DATE: February 17, 2026
TO: ALL CONTRACTORS
FROM: DUSTINE TILL
PROJECT: ROSCOE ROAD WATER TREATMENT PLANT
ORANGE BEACH WATER AUTHORITY
GMC PROJECT NO. CMOB230049
RE: ADDENDUM #3

ADDENDUM NUMBER 3

ROSCOE ROAD WATER TREATMENT PLANT

GMC PROJECT NO. CMOB230049

D-506

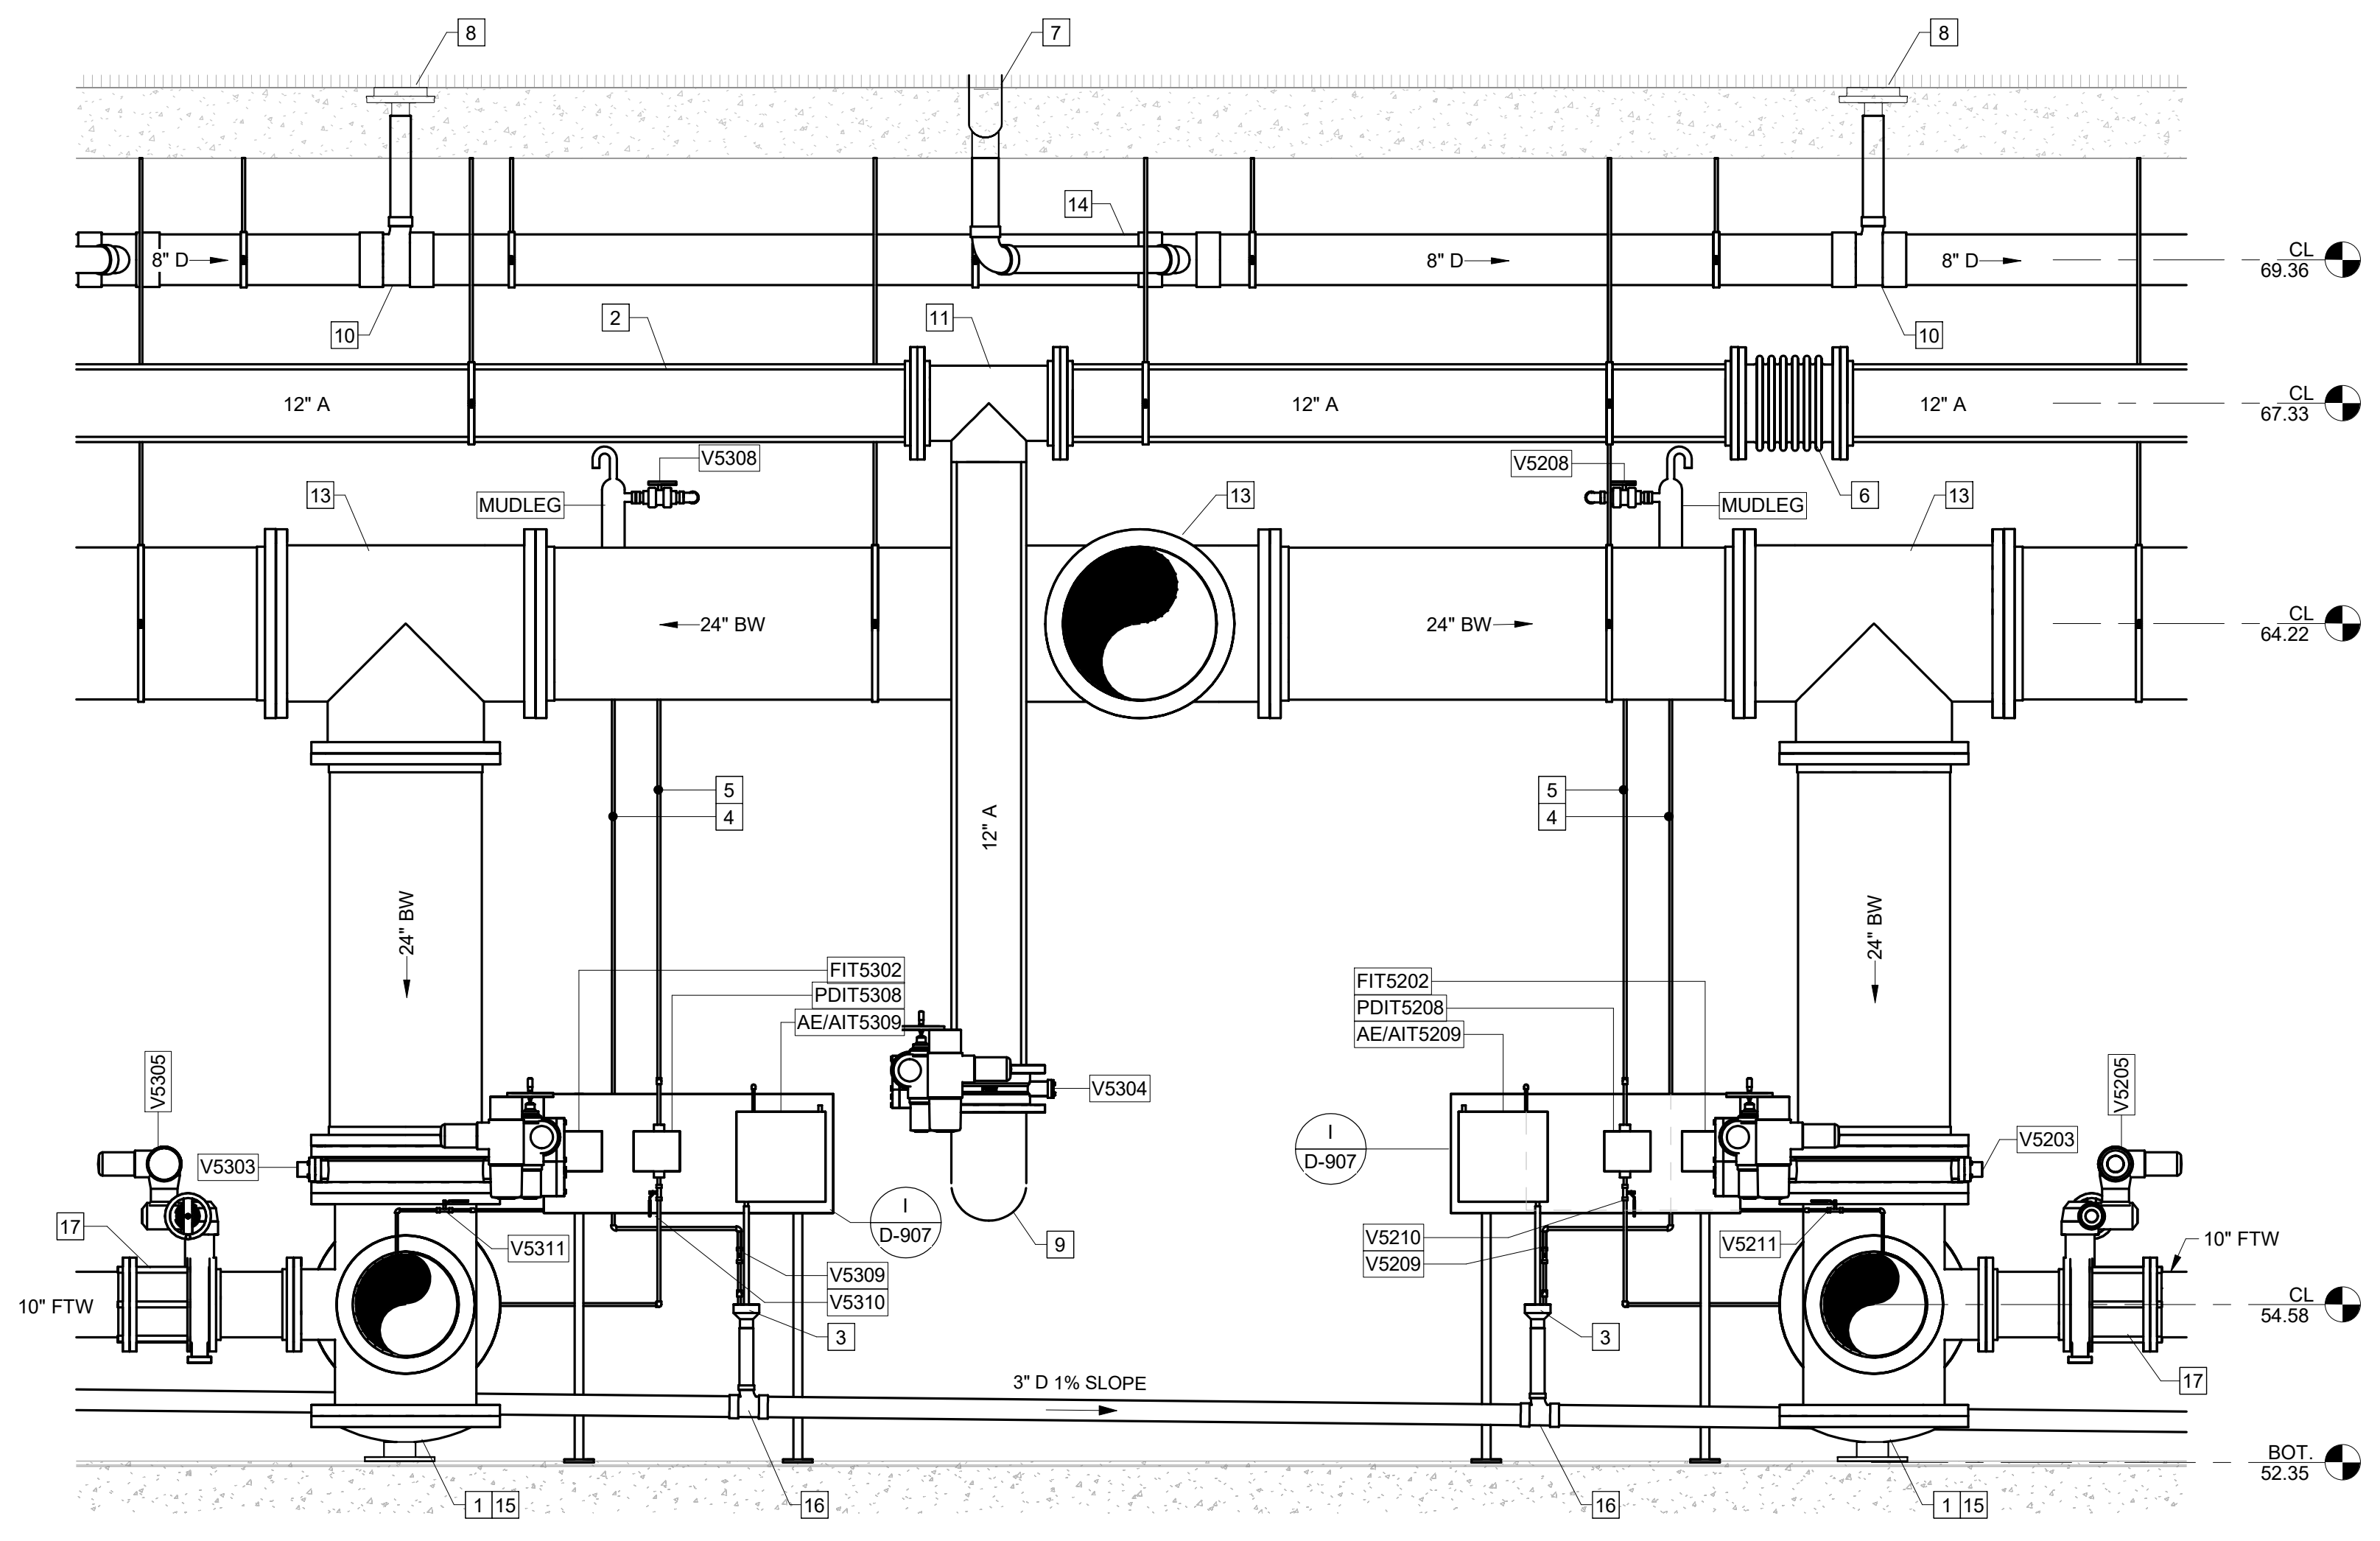
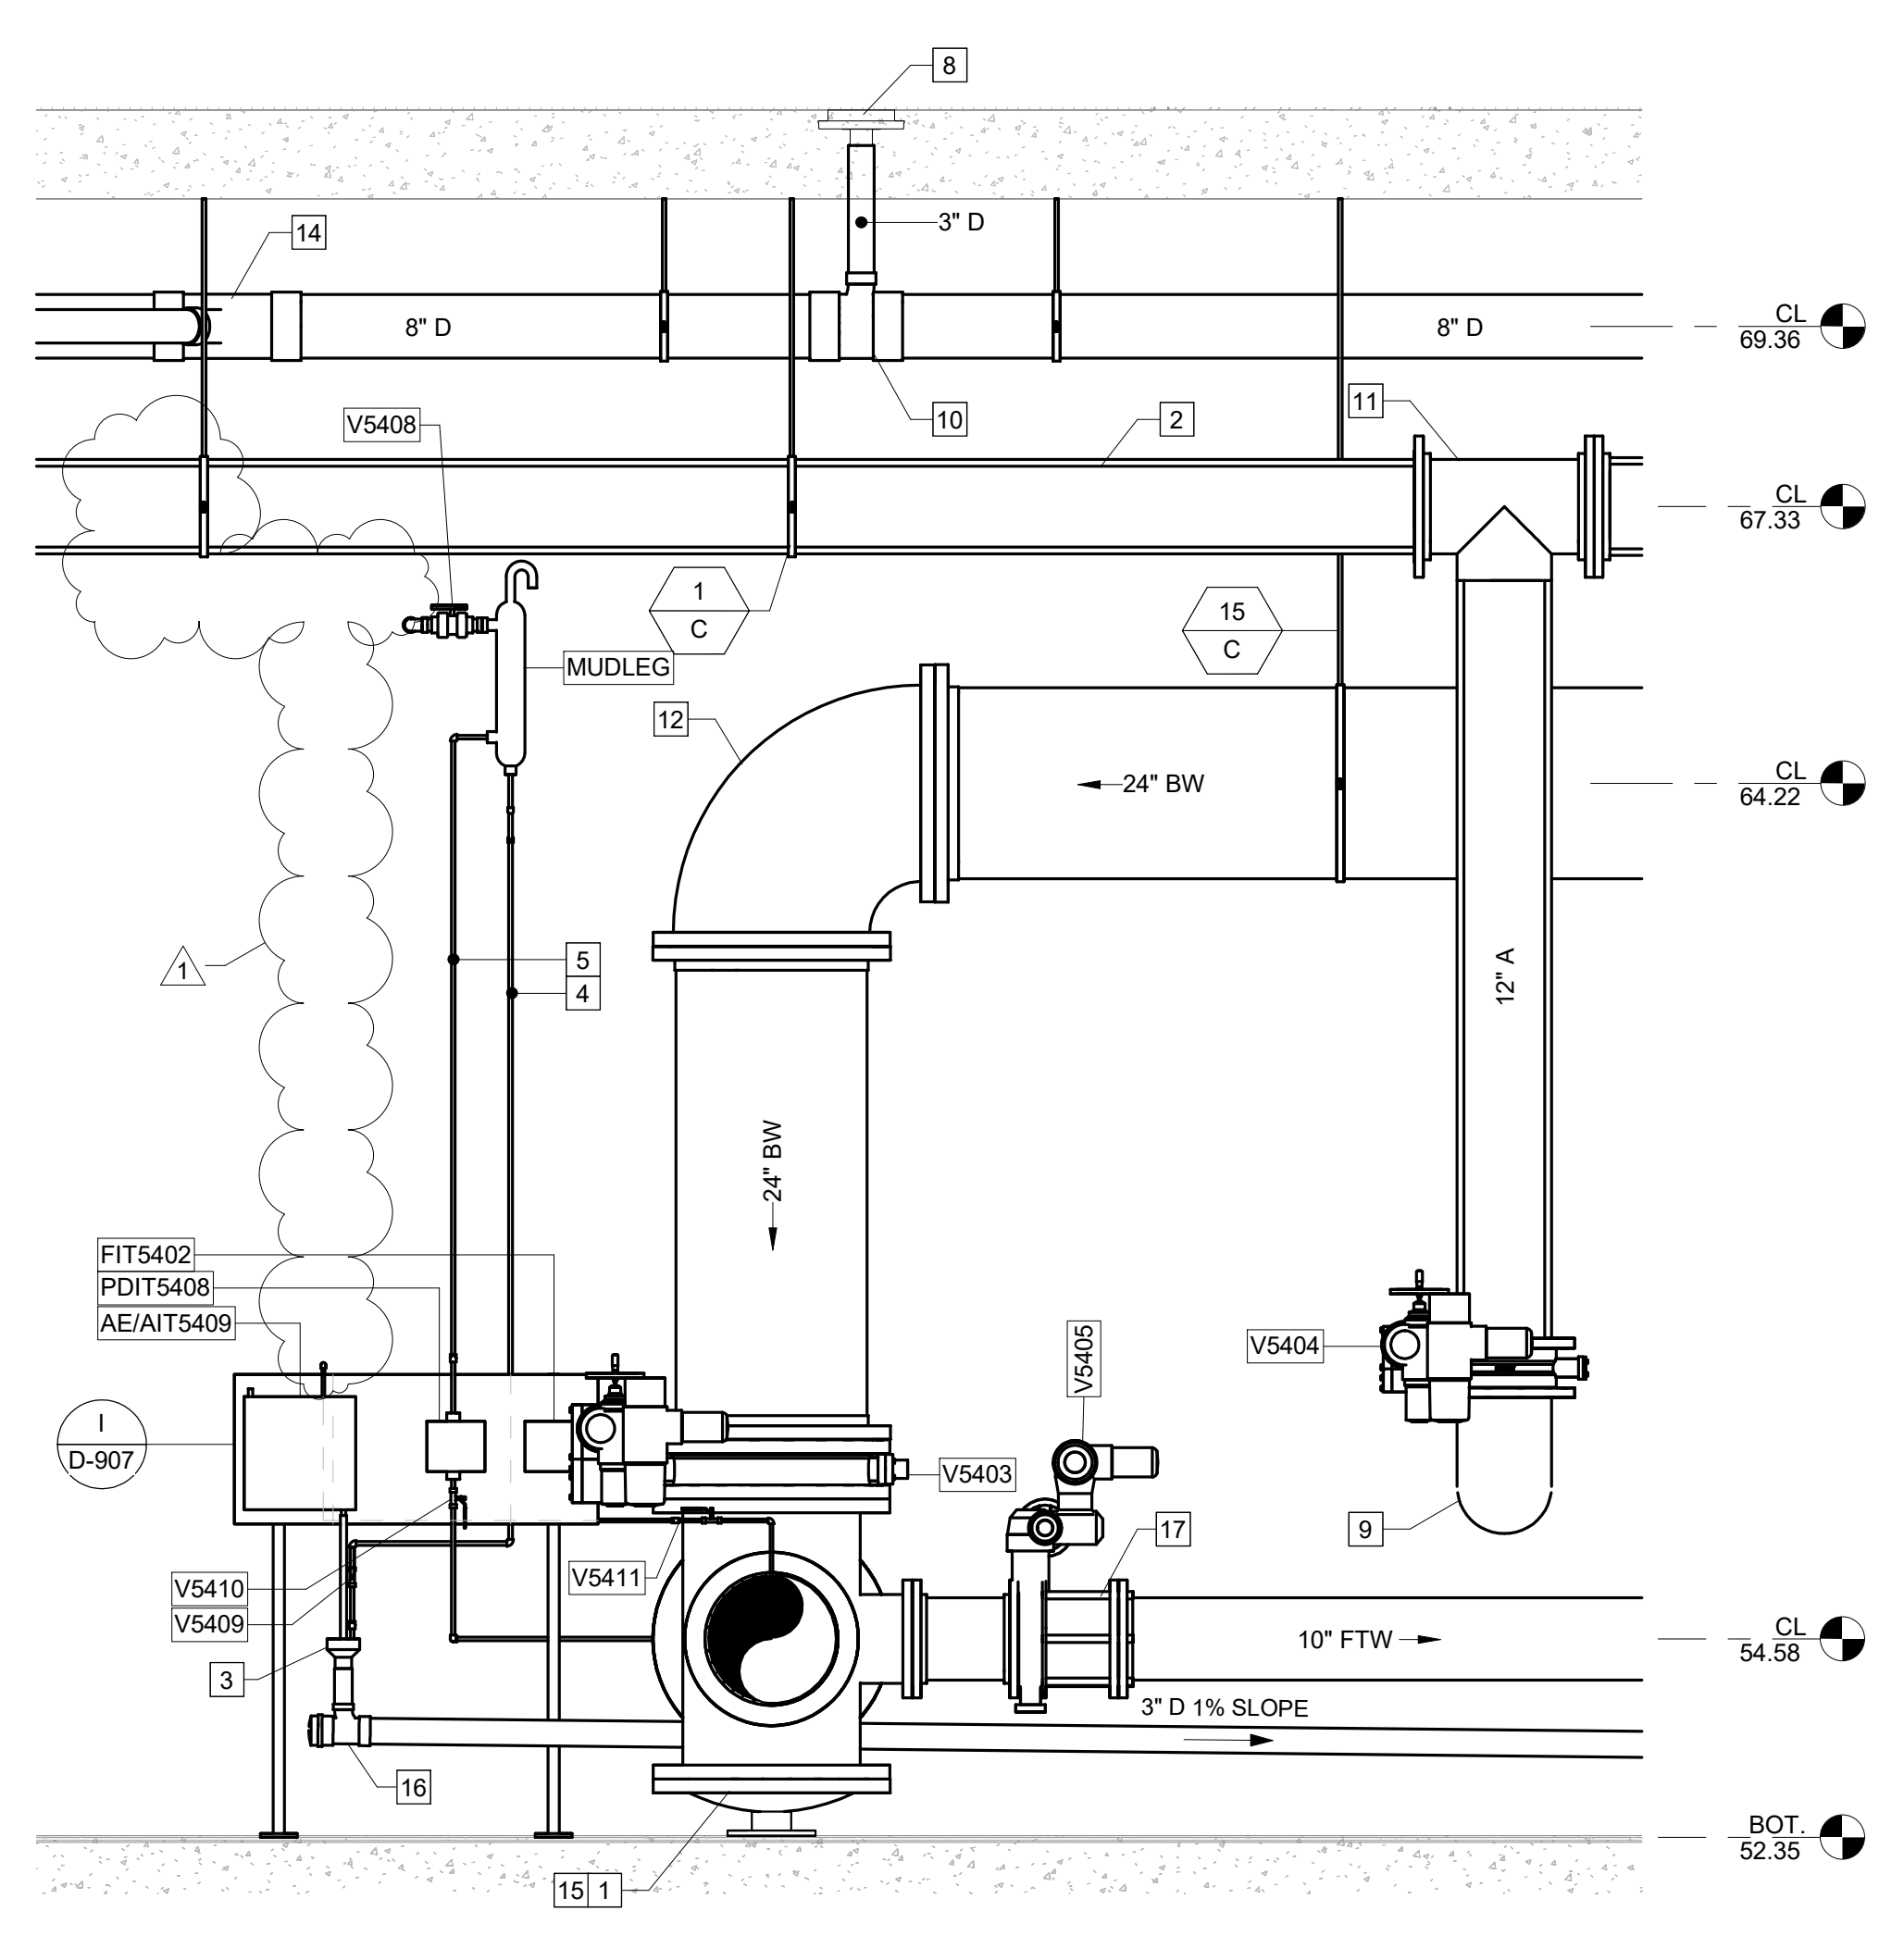
5.3 **Question: What product is intended to be used for what appears to be a coupling on the 12" SST Air line shown on Drawing D-506, Section E? Is the ½" Air Line shown intended to be tapped off of the coupling? Where does the ½" Air Line go?**

Answer: There should be no coupling as shown on the 12" air line on D-506. The 1/2" line (labeled 1/2" A) can be omitted.

Answer: Yes, valves V5715, V5725 & V5750 are 10".
- 5.24 **Question: Please confirm the 8" Drain Line, shown on sheet D-506, is made from Sch. 80 PVC pipe and fittings. The Pipe Schedule calls for exposed 'D' lines 4" and larger to be Ductile Iron but this particular area is drawn as if it's PVC.**

Answer: Yes, the 8" Drain line suspended from the pipe gallery ceiling shall be SCH 80 PVC.
- 5.25 **Question: Please confirm valves V7012 and V7022 should be provided with flanged ends. They are shown on sheet D-711 in a flanged system but are called MJ in the Valve Schedule.**
